**Re: GAHP Casa Feliz
512 San Pablo Street SE
Request Permanent C.O. - Accepted
Engineer's Stamp dated: 12-18-15 (L19D073C)
Certification dated: 3-16-17**

Drainage Certification (L19D073C, DRB#1010674)

ENLARGED
SITE DRAINAGE PLAN
NORTHERN PART OF
BUILDING B

ENLARGED
SITE DRAINAGE PLAN
SOUTHERN PART OF
BUILDING B

TYPICAL POND DETAIL

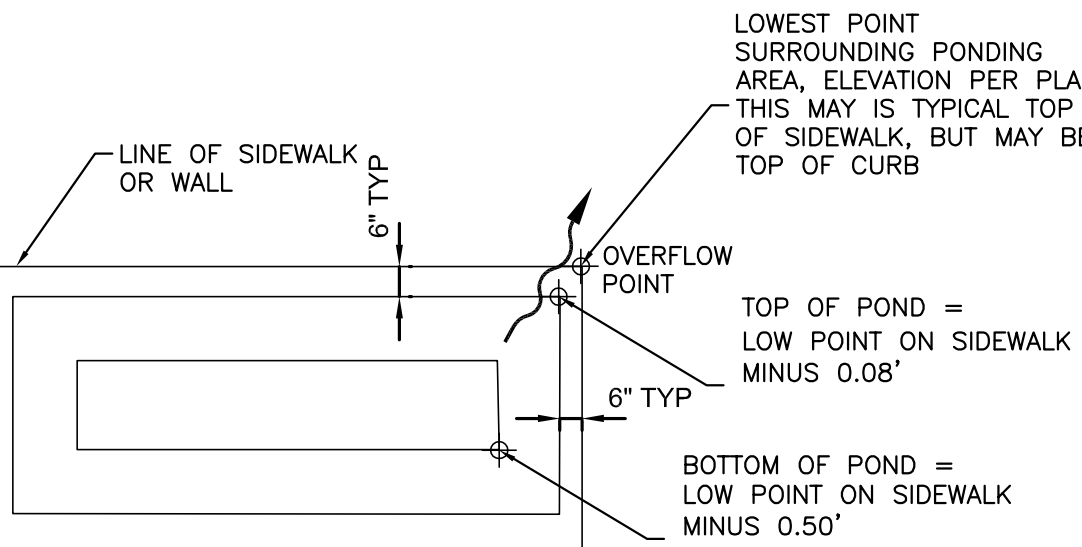
This detail requirement was removed after release of the building permit. Please refer to the email correspondence with City of Albuquerque Hydrology Staff dated May 3, 2016 attached with this submittal.

This pond eliminated.

I agree that the 4" PVC pipes should be eliminated, and that the first flush ponds should overflow across the sidewalks in a sheet flow manner. Rather than resubmit a revised grading plan, with a new approval, this email serves as Hydrology's acceptance of this change and will be added to the drainage file to document the change. Please be sure to note the change on the As-built drawing when requesting C.O.

TYPICAL POND DETAIL

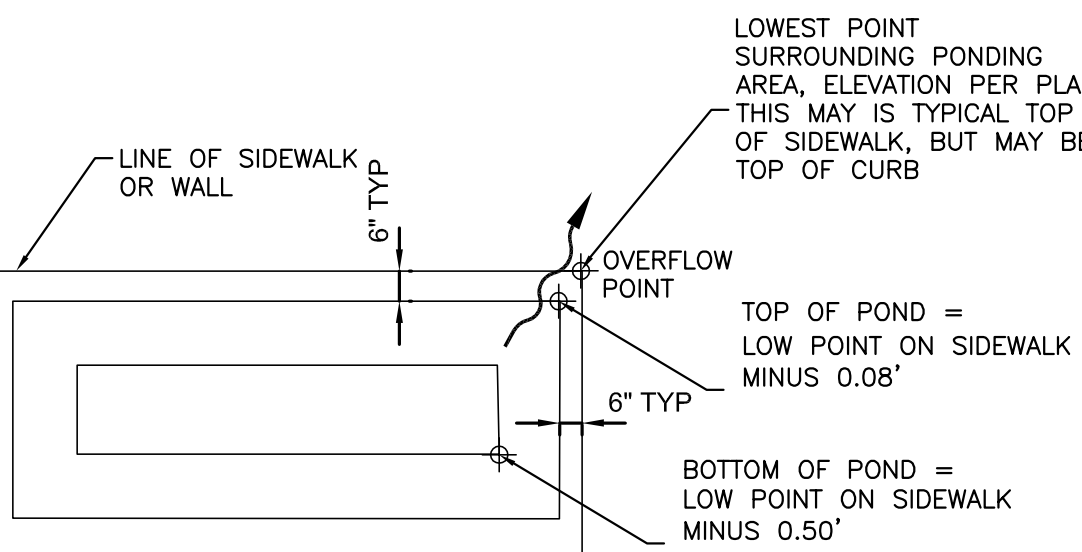
This pond eliminated.
